FISCAL SHEET TOTAL YEAR NO. SHEETS PROJ. NO. HAW. | HSIP-2050(007) | 2017 | ADD. 7 | 35

ADD. 7 S-1

SHOULDER PULLOUT AT PAVED DRIVEWAY DETAIL Not to Scale

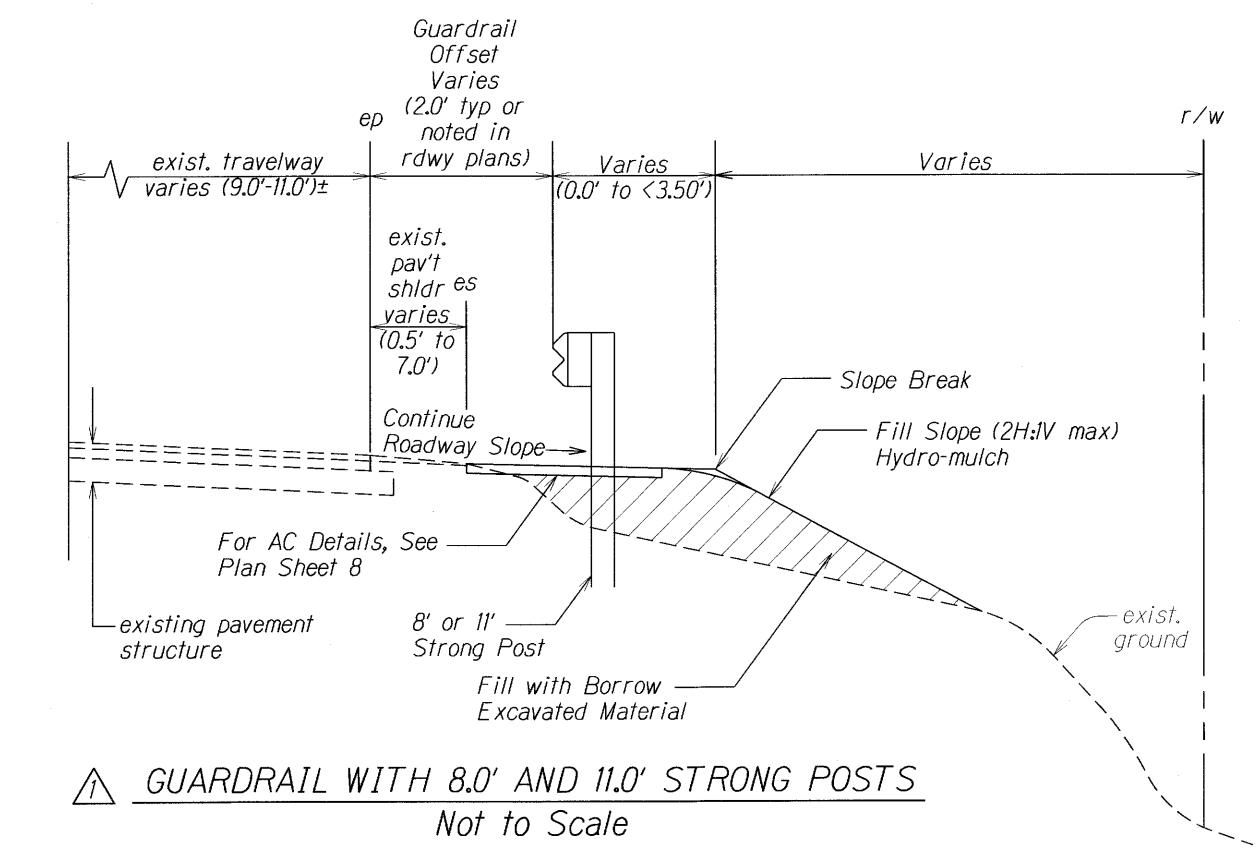
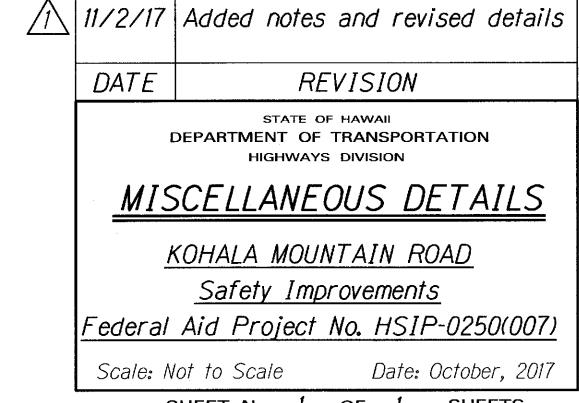
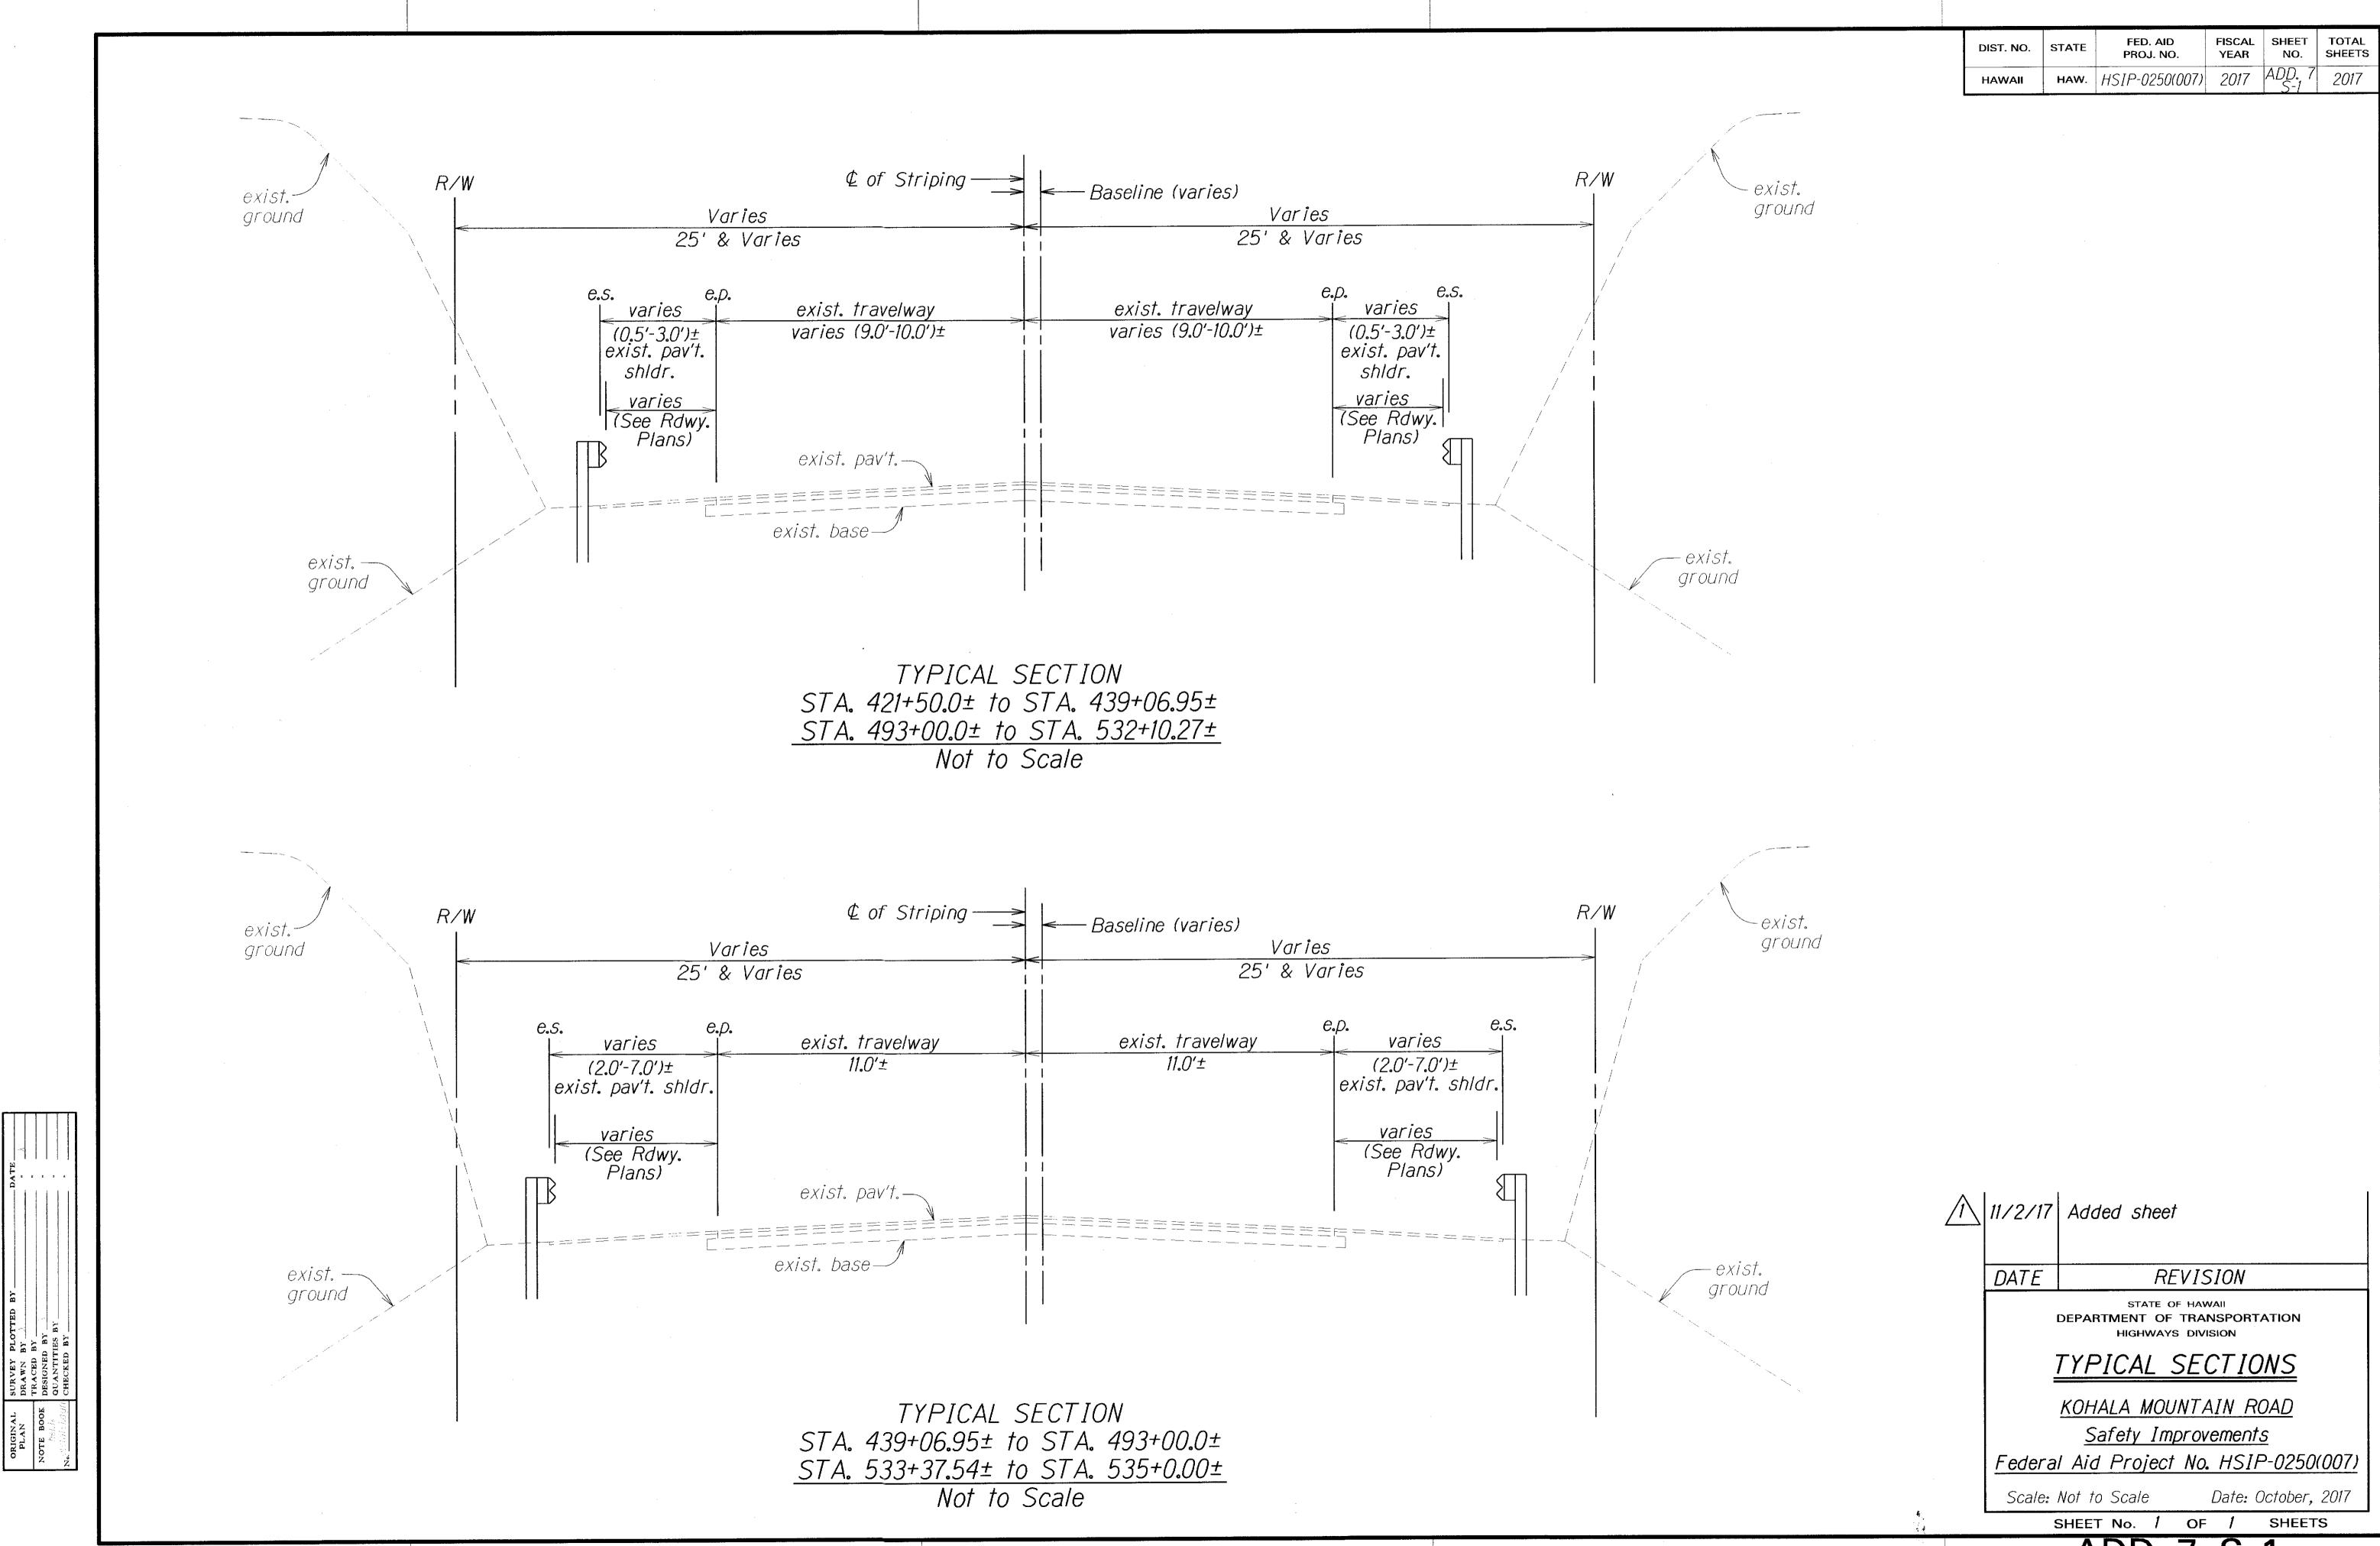
Contractor shall mount a device directly on the paver screed extension to provide a 30° beveled shoulder edge.

Contractor shall mitigate pavement drop-offs which shall be approved by the Engineer.

- 8' strong post shall be installed in areas where the length between the fill top slope break and front face of guardrail is between 0.0' and 3.50'.
- 11' strong post shall be installed in areas where a max fill slope of 2H:1V behind the front face of guardrail is not feasible within the State's right-of-way. If the existing top slope break is located within 2.0' of the ep, offset the front face of guardrail 1.0' from the ep and taper the approach and trailing ends with a minimum of 18:1 flare. This work shall be considered incidental to Guardrail Strong Post W-Beam 11.0' Post. No additional fill slope will be needed in these areas.
- Additional paved area shall be installed up to the existing paved edge of shoulder.
